ADDENDUM NO. 1

Date: 7/11/2017

Project: Field Improvements at West Campus High School

West Campus High School
Synthetic Practice Field & Road Improvements, Inc. 1

1
A
B
C
D
E
F
G
H

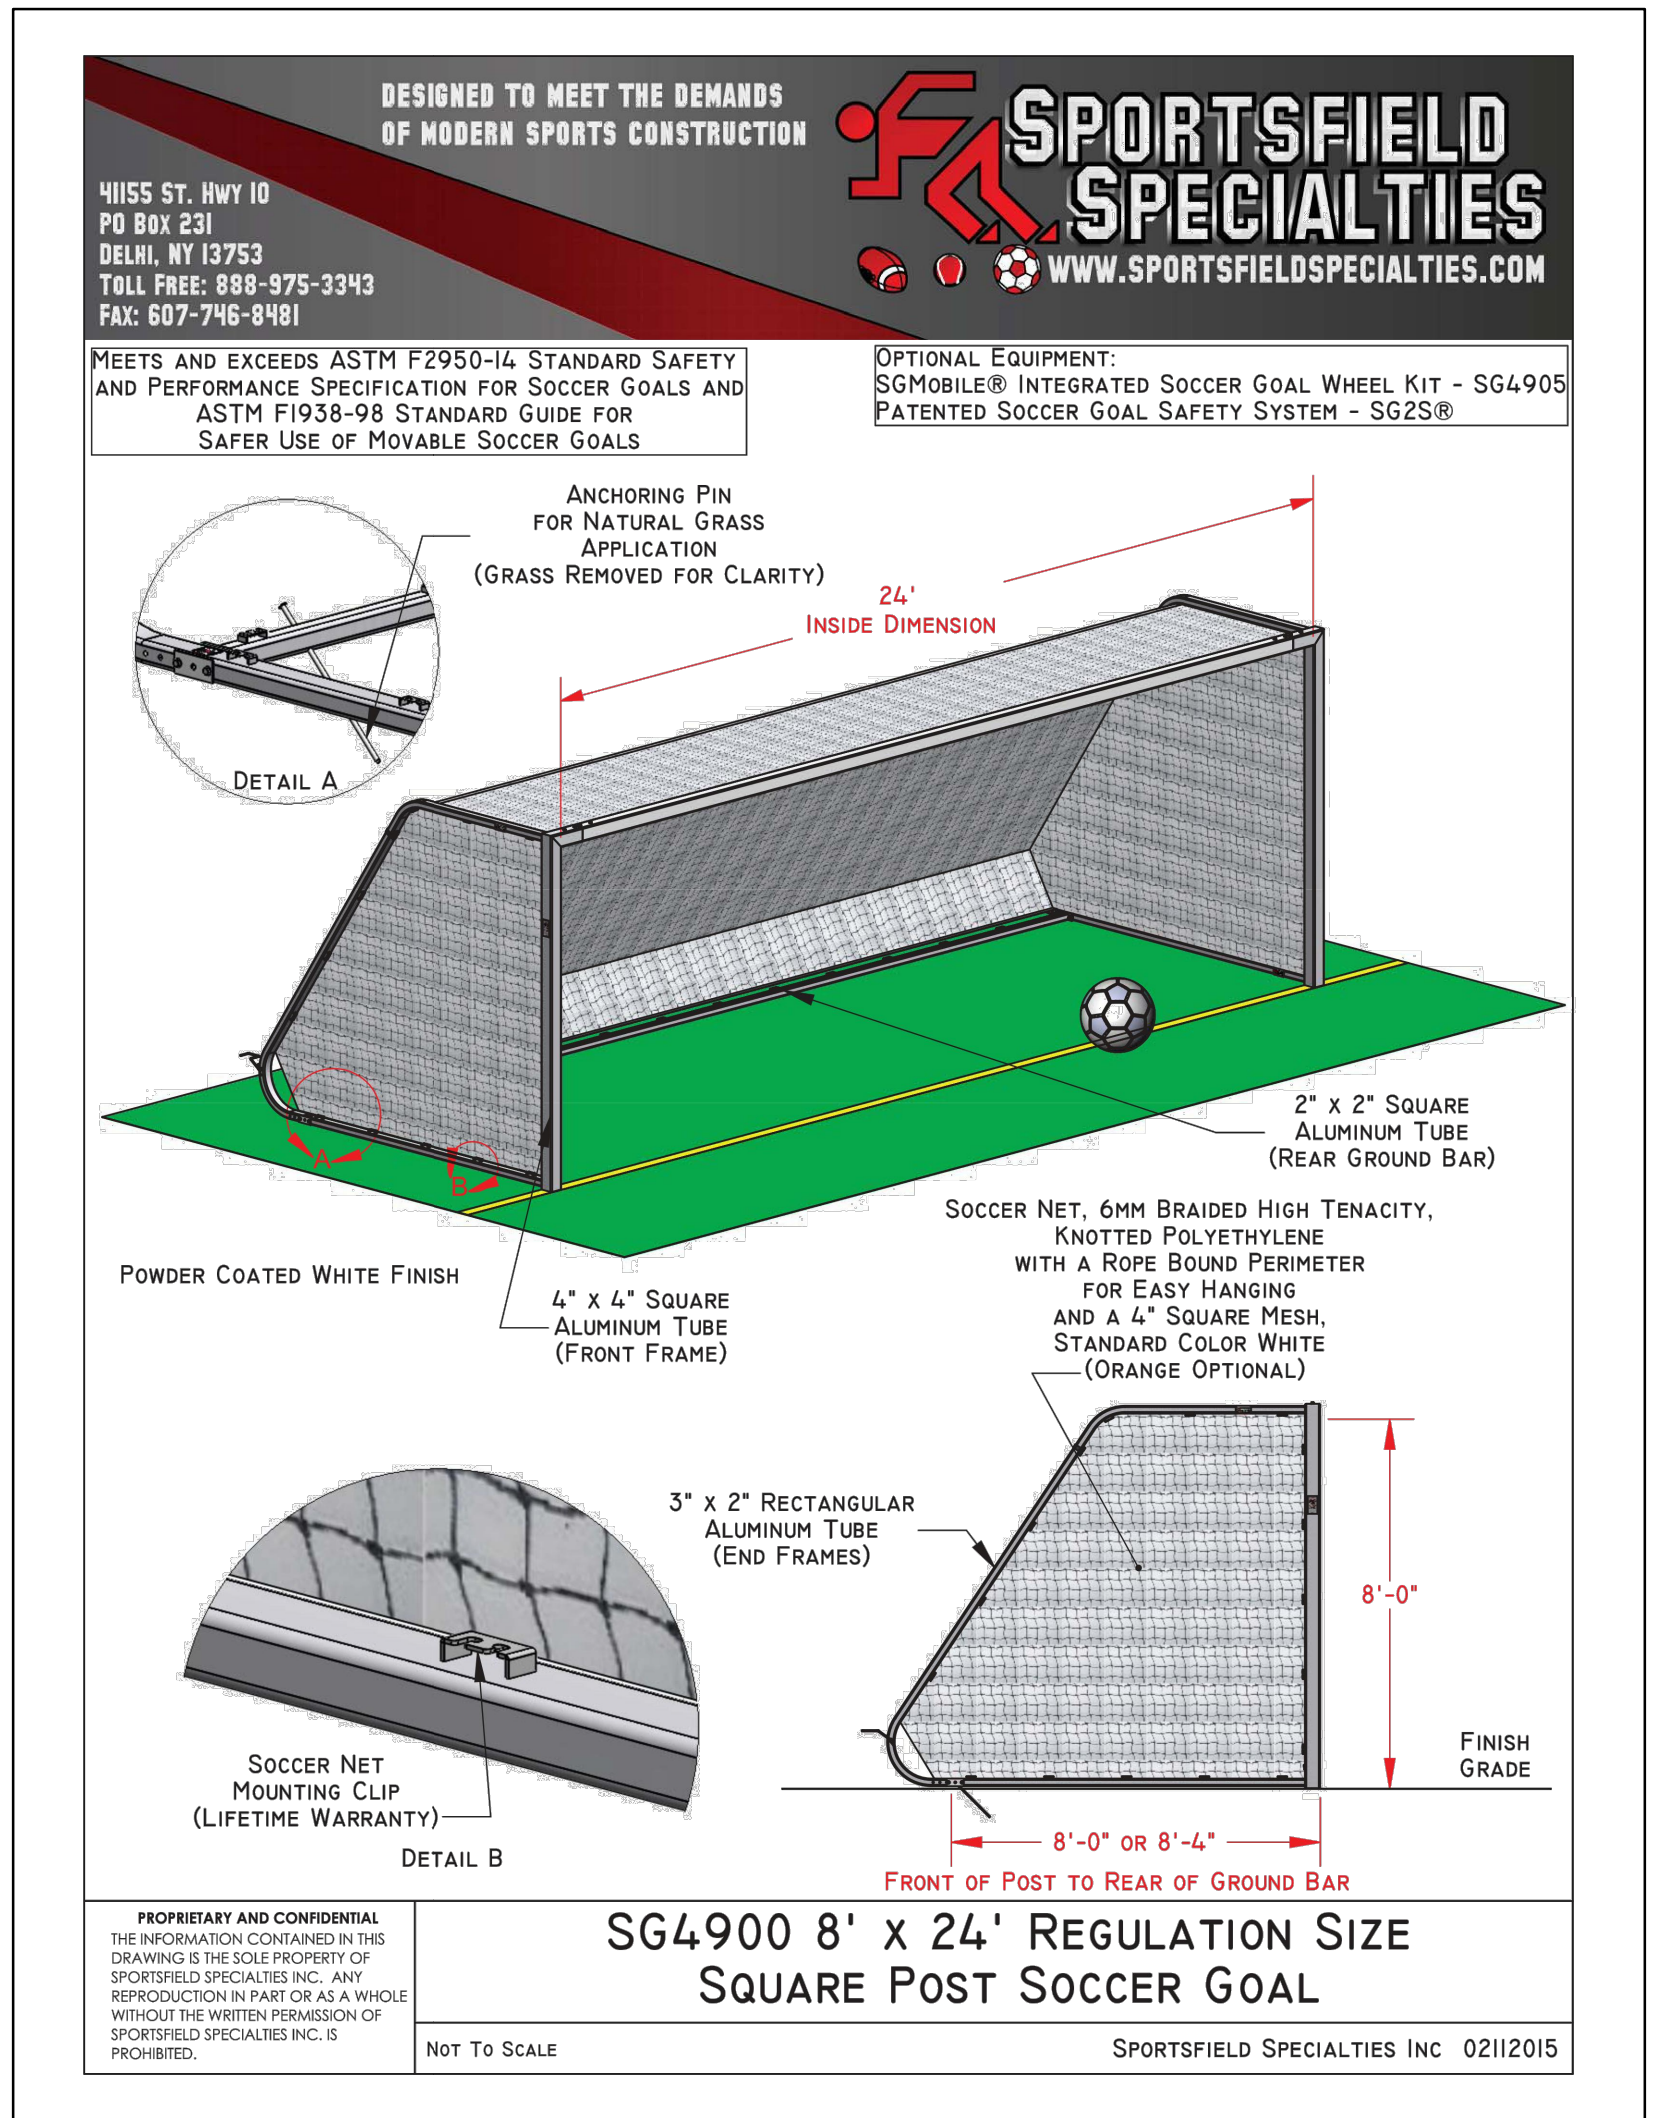
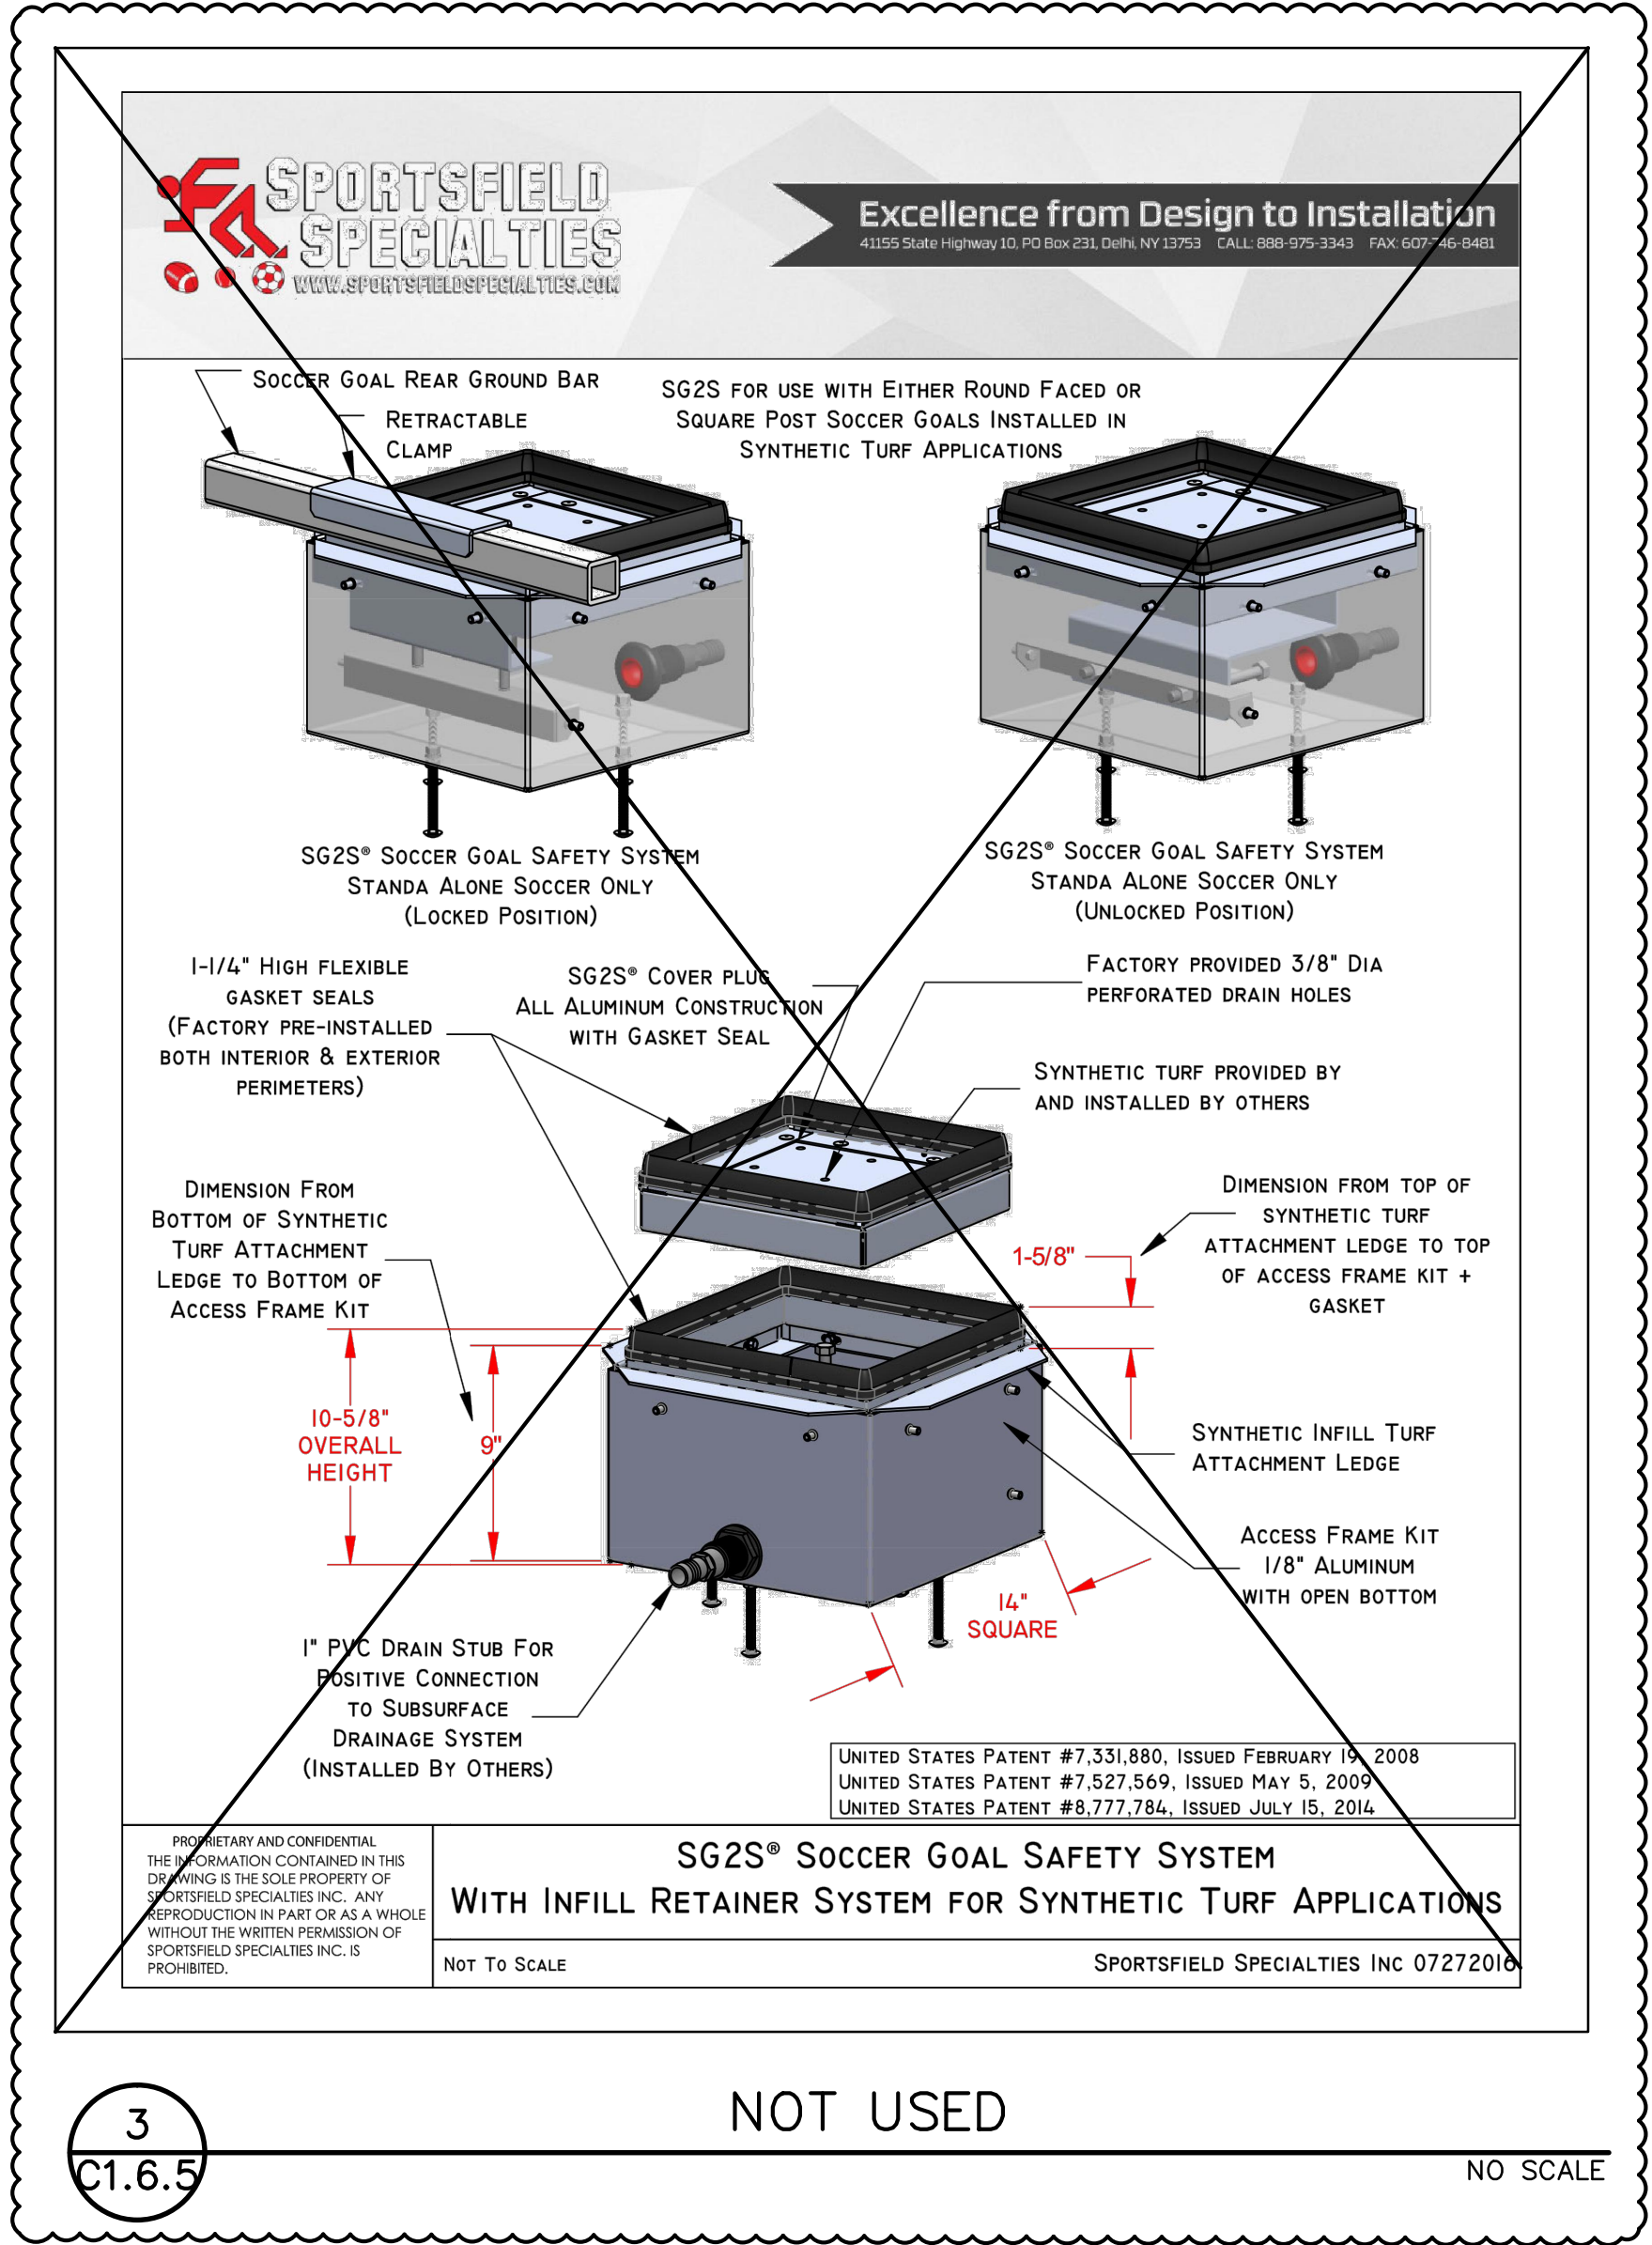
7. AD1-7 FIELD LAYOUT PLAN
 - a. Ground sleeves and soccer lock down to be installed at both goal ends.
8. AD1-8 FIELD FENCING AND EQUIPMENT PLAN
 - b. Only goal sleeves to be installed, goal posts to be provided but not installed.
9. AD1-9 FIELD FENCING SECTIONS AND DETAILS
 - c. Goal post to be provided but not installed.
10. C1.6.5 FIELD EQUIPMENT DETAILS
 - d. Some equipment not used.
11. C1.8.3 DETAILS AND SECTIONS
 - e. Field section detail updated.
